**FIRE ALARM COMPLETE  
PLAN SUBMITTAL**

**RUTH HARDING SCHOOL  
MODERNIZATION**  
3201 PICO ST.  
FOR  
**BAKERSFIELD CITY SCHOOL DISTRICT**  
BAKERSFIELD, KERN COUNTY, CALIFORNIA

**FIRE ALARM  
SITE PLAN**

**FIRE ALARM SITE PLAN**

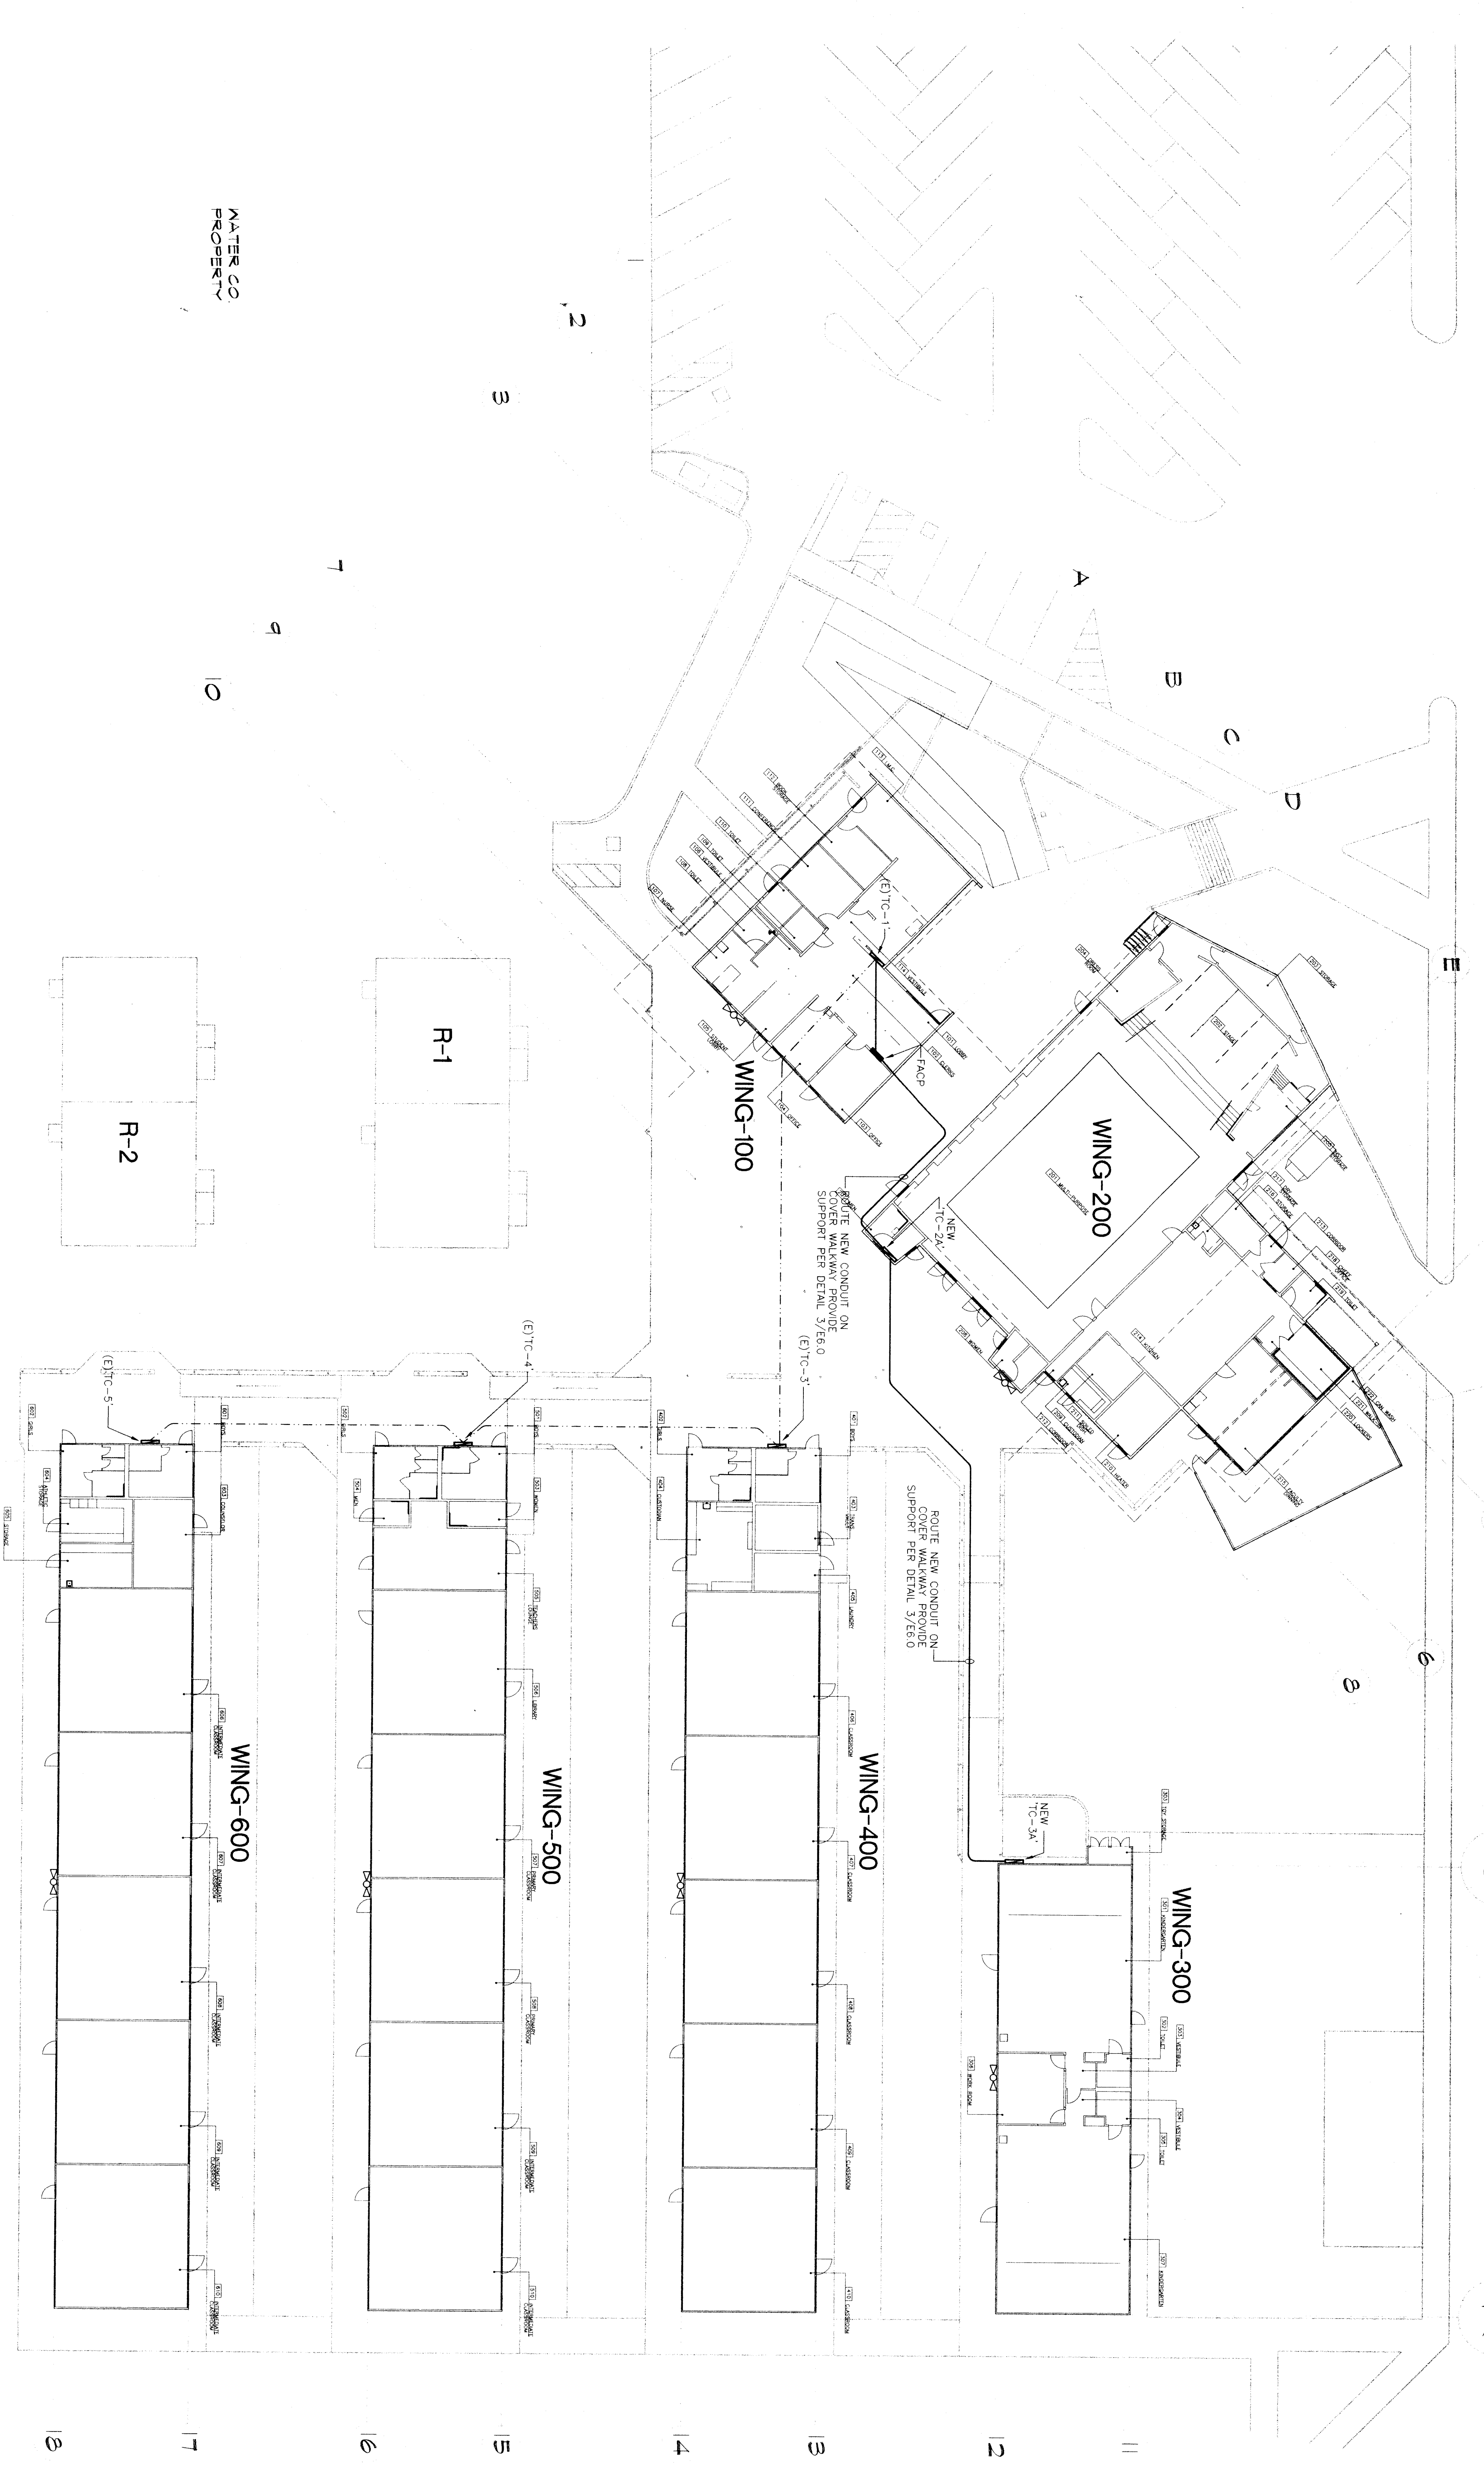
49. Refer to Electrical Drawing ES.0, Fire Alarm Site Plan, for details. All wiring has been expanded to include a fully automatic detection system. Refer to Drawings ES.0, ES.1, ES.2, ES.3, ES.4, and ES.5 for expanded scope, as attached to this addendum.
